LeBreton Library Parcel

Constructability Report

February 2023 | TYLin Ref. 10399

The team acknowledges receipt of City comments on the initial issue of the Constructability Report (transmitted by email on November 8th 2022), comprising a memo by Stantec with comments on various aspects of the project in relation to CSST Infrastructure. Please refer to **Appendix H** for a copy of the Stantec memo, along with a response memo from Golder describing additional analyses undertaken and point-by-point responses to the Stantec comments.

PROJECT No.
10399
FIGURE No.
1-1

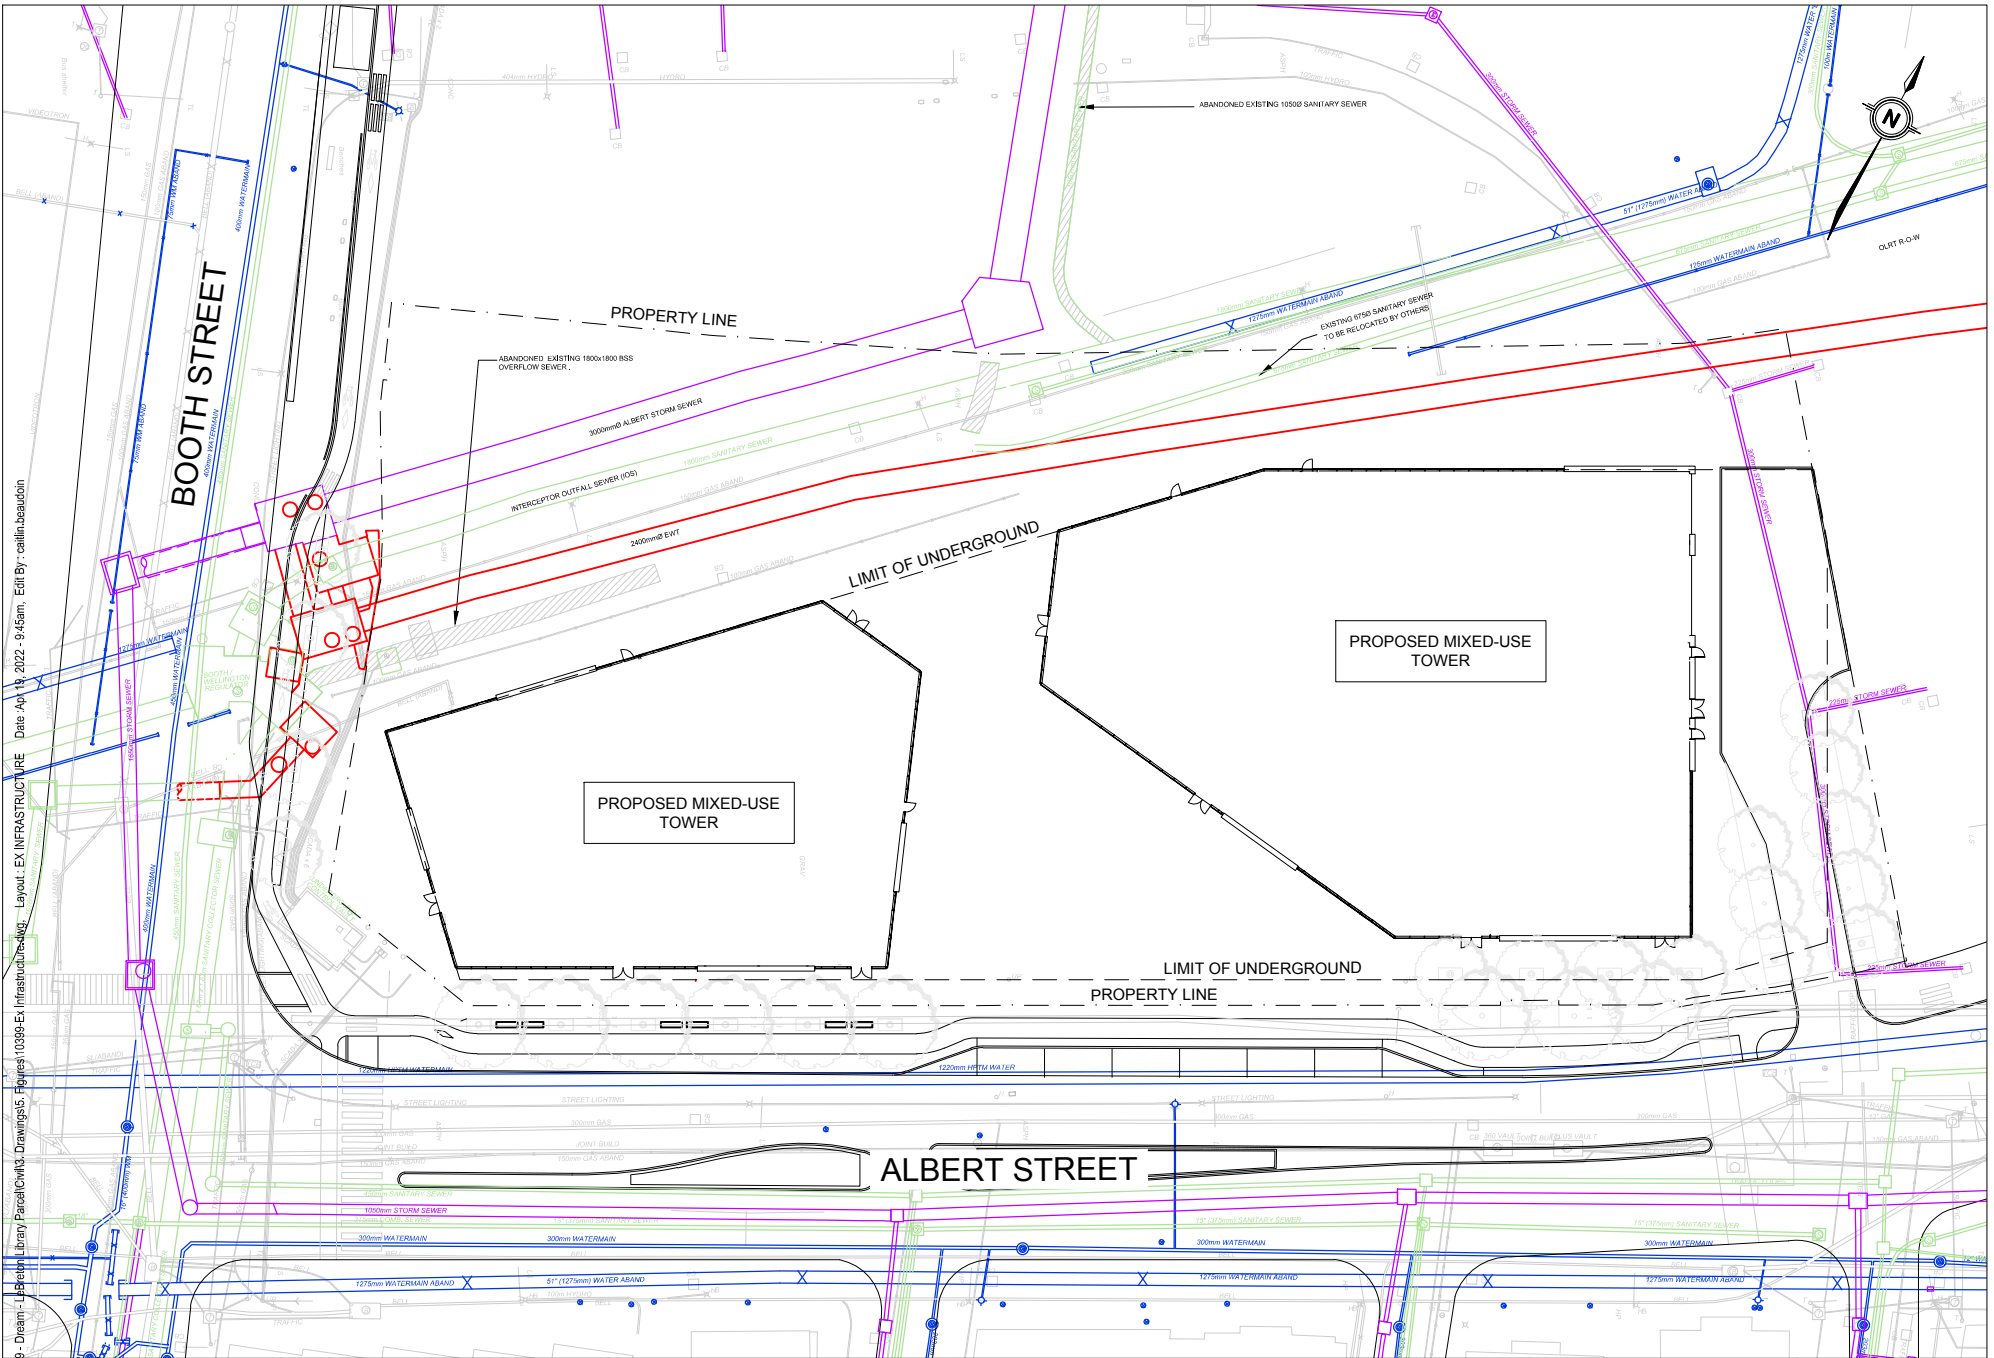
- a. The plans included within the constructability report (Figure 1-1) appears to show the existing Real Time Control (RTC) underground control vault at Booth/Albert and the associated underground ductbanks from this vault to the RTC facilities. It is unclear how/if the infrastructure is affected by the work, but this should be reviewed and addressed by the proponent. Excavations may extend into the footprint of the vault and the ductbanks, potentially requiring temporary support and protection.

Figure 3-1 LLP-LOG-02 Extract

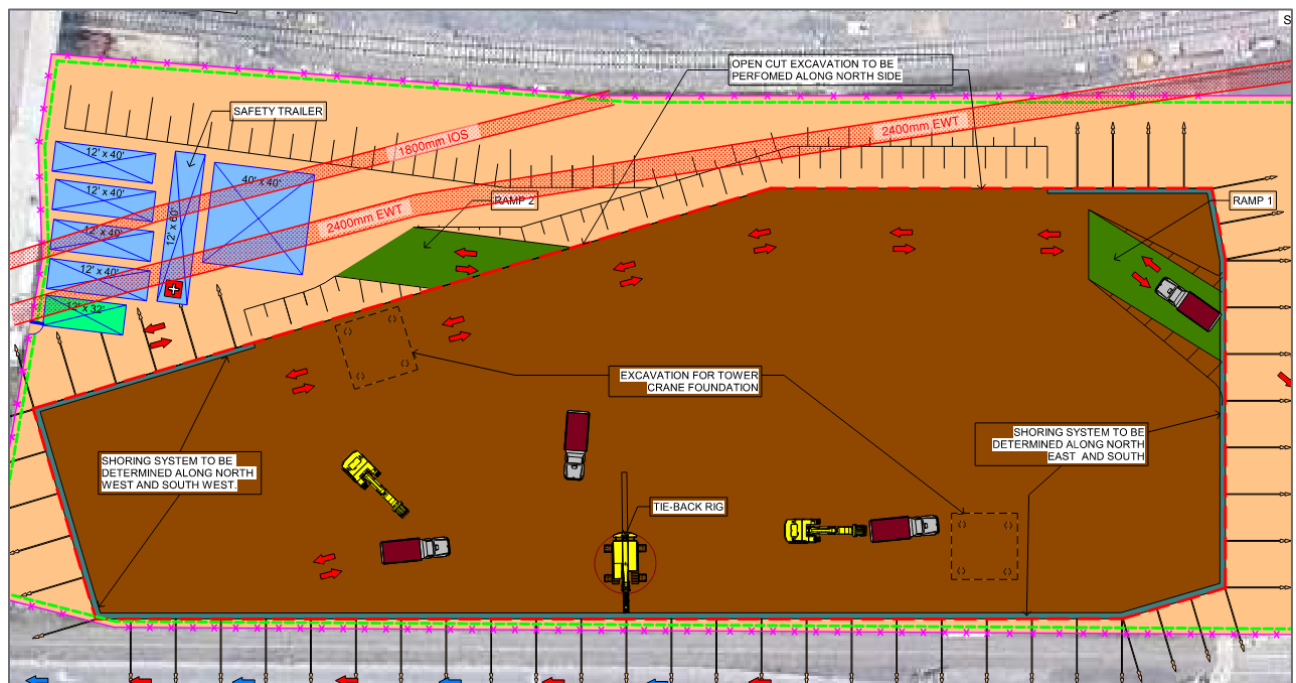
Revised report does not address comment fully. However, landscaping cross-sections illustrate that final grades for the MUP (lowest elevation area of site) will be at 56.0m at a minimum, consistent with the grades of the existing LRT tracks that are above-adjacent to the existing sewer infrastructure. It is assumed that the construction site overtop of the EWT and IOS will not be excavated lower than 56.0m outside of the shoring system (essentially existing grades). Provide confirmation whether any protective measures would be required to protect the sewers from construction activity/equipment.

In response to this comment, we note that no excavation lower than 56.0m is proposed over City infrastructure. As per the ED Logistics Plan Excavation Figure LLP-LOG-02 (**Appendix F**) and Marathon Shoring Plan (**Appendix E**), construction site grades in the northern portion of the site over existing City infrastructure will generally not vary significantly from the existing condition. As indicated in **Figure 3-1** (a marked-up extract of the Ellis Don Logistics Plan Grading Figure LLP-LOG-02 to show approximate alignment of EWT/IOS), City infrastructure lies outside of, or close to, the indicated top of slope linework. In localized areas some precut (to an elevation of 59.0m) will be necessary as part of excavation shoring (see Marathon Drg. MU4). On this basis, no additional protective measures are considered necessary.

Figure 1 - Example Cross Section Along North Foundation Wall

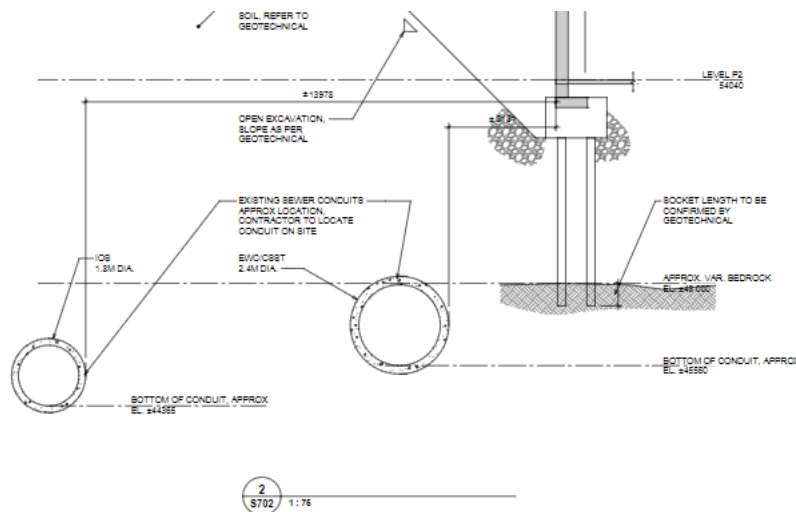
Based on information contained in the Stantec memo as well as the RJC drawings, there is an existing 2.4 m diameter precast concrete sewer which forms part of the CSST infrastructure. This sewer is referred to as the EWT tunnel. The EWT tunnel is located 3.2 m from the exterior wall at its closest point to the new building (see Section 2 on Sheet 702 of the RJC foundation drawings). At all other locations the distance is greater than 3.2 m.

- Comment 3a: Golder has reviewed the foundation drawings and confirms that there are no additional loads expected to be applied to the EWT by the proposed foundations.
- Comment 3b: The current RJC drawings indicate that the caisson foundations will have a diameter of 1.2 m and will have a rock socket depth of 3 to 4 m.
- Comment 3c: The statement is not included in the geotechnical report because the foundations were not designed at the time of preparing the report. We believe this statement in the constructability report refers to subsequent correspondence and discussion. Regardless, it is Golder's opinion that the currently proposed foundations should not impose any significant stress increase to the existing services in question and, notwithstanding the reference, the statement in the constructability report is generally valid.

- Comment 3d: The caissons are designed to have a rock socket depth of 3 to 4 m which is approximately 3 times the proposed diameter. This would typically be sufficient to be considered fixed (though the quality of the rock sockets does need to be confirmed during construction).

- Comment 3e: Given the discussion above, the increase in stress due to the permanent foundations is expected to be essentially zero.
- Comments 4a to 4e: These comments relate to shoring and temporary works which are designed by others. Golder would be pleased to provide additional review as required as these aspects of the project are designed in further detail.
